Appendix G – Drainage Drawings

Project HIGHGATE SCHOOL
DYNE HOUSE

Appendix I – TW Correspondence

From: "DEVELOPER.SERVICES@THAMESWATER.CO.U"
<DEVELOPER.SERVICES@THAMESWATER.CO.UK>
To: fiona.w@expedition.uk.com
Fred Labbe <fred.l@expedition.uk.com>; John Gerrard
<john.g@expedition.uk.com>; Andrew Komarnycky
CC: <andrew.k@expedition.uk.com>; Jack Gregory <jack.g@hopkins.co.uk>; Daniel
O'Connell <Daniel.O'Connell@highgateschool.org.uk>; Gwyn Jones
<Gwyn.Jones@highgateschool.org.uk>
Sent: 11.10.18 14:40:22
Subject: RE: RE: RE: RE: RE: RE: DS6051776 PDEV N6 5EE Dyne House Highgate

DYNE HOUSE HIGHGATE SCHOOL - PROPOSED DIVERSION OF EXISTING TW SEWER FOR DISCUSSION- EXPEDITION 27/07/18 - REV 3
SKETCH NO.: 585-SK-TW-01

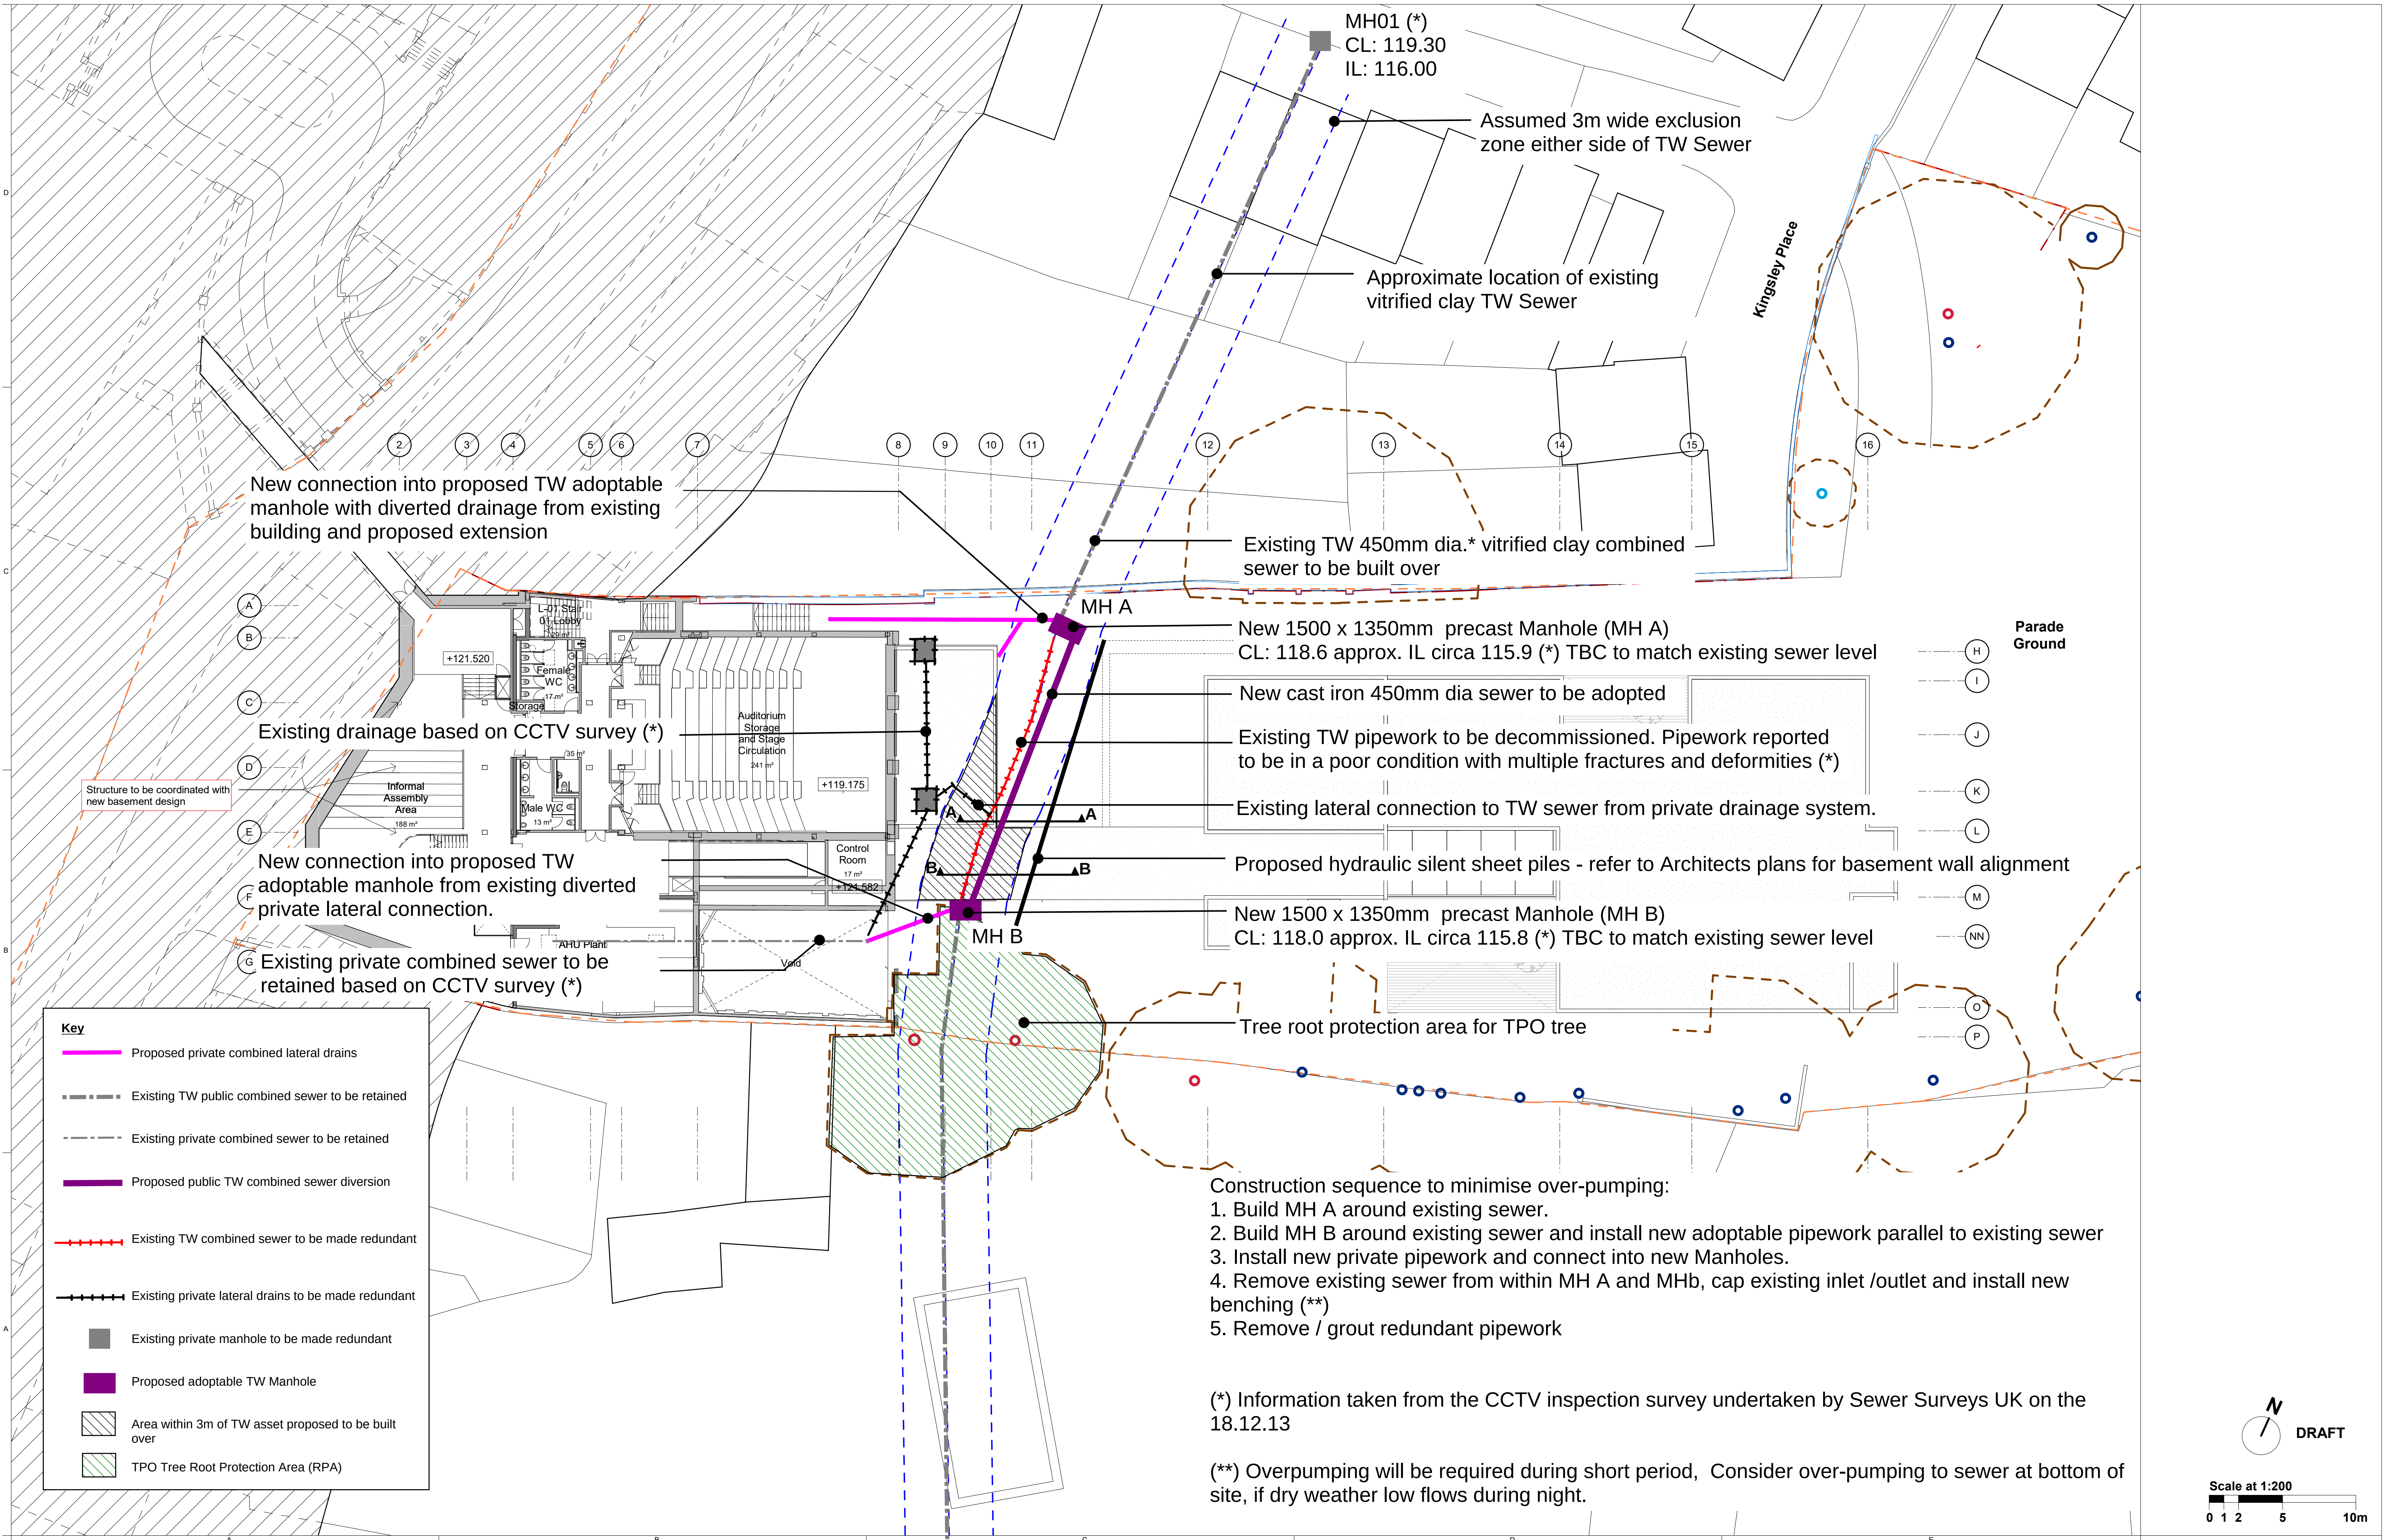
Rectangular 1500mmx1350mm manhole is not standard in SFA 7th, and I suspect you may struggle to profile the benching for 450mm sewer. I therefore must be adamant to see the design of this manhole before issuing a technical approval.

Can you update your proposed drainage layout with the following standards and provide additional documents as per below list please?

1. Site plan layout showing location of the manholes with cover and invert levels, sewers with pipe diameter and gradients, site boundary. Include the following statement: 'All adoptable drainage works to be constructed as detailed in Sewers for Adoption, 7th edition' or as stipulated in Thames Water's Addendum.

2. New sewers long sections with proposed cover and invert levels, pipe dia and bedding class.
3. Construction details.
4. Estimated value of construction works
5. Manhole schedule.
6. Method statement for the removal of the existing sewers

We are happy for the new sewer being laid with 1.5m clearance from the piling under following 2 conditions:

1. The piling is undertaken before the sewer is built and adopted
2. The cctv is carried out to check the condition of the sewer after the piling.

Unfortunately, I must be adamant in terms of the new manhole though. It needs min 700mm clearance distance from the external face of the building. This is due the requirement of the safe access for maintenance. It also should be constructed after the piling.

1. The minimum distance from the new sewer to the foundation piles should be 3m.
2. Please provide construction details of the new manholes
3. Please leave a void space between RC ground beam and the top of the ground cover, to prevent impact of the beam deflection onto the new sewer.
4. All manholes should be constructed with min 1.2m distance from the face of the building.

Thanks for your email, we are not yet at that stage of developed design to have construction details available. The construction details will be in accordance with Sewers for Adoption 7th Edition. Is this sufficient for you to process the application.

As requested please find updated proposed drainage layout in line with the standards and additional information requested below.

We accept both the conditions stated below regarding the piling and also that associated with the new manhole.

1. The current proposals are to replace a section of existing pipework in poor condition and as such we are constrained with the alignment for the replaced section of pipework. The a new section of cast iron pipework will provide significant improvements to the existing public sewer and we believe the proposals will have minimum impact on the sewer. We have based the proposed foundation design on specification 5.2 provided in the conditions for the grantor undertaking form which states:

When using piled foundations, the proposed foundations are to be a minimum of 1.5 metres from the public sewer. Only continuous Flight Augured piles are acceptable.

2. The new manholes will be constructed in accordance with Sewers for Adoption 7th edition – Typical manhole detail Type 2.
3. Based on the anticipated Invert Levels of the existing sewer, it is believed there will be approximately 1.5m from the RC ground beam to the crown of the sewer, therefore any deflections will have minimal impact on the sewer below.

4. The existing public sewer does not have any manhole access points at this location. Our proposals are to provide a manhole upstream and downstream of the section of pipework being built over to improve access to sewer and in particular the existing lateral connection from the building which is to be maintained. The location of the manhole as currently shown is at the edge of the tree root protection area of a TPO tree. We are not able to move the manhole further away from the proposed building without significantly and unacceptably impacting on the roots of the TPO. We believe that the current proposals to introduce two additional manholes provides TW enhanced access to the sewer in the future and is an improvement on the existing access.
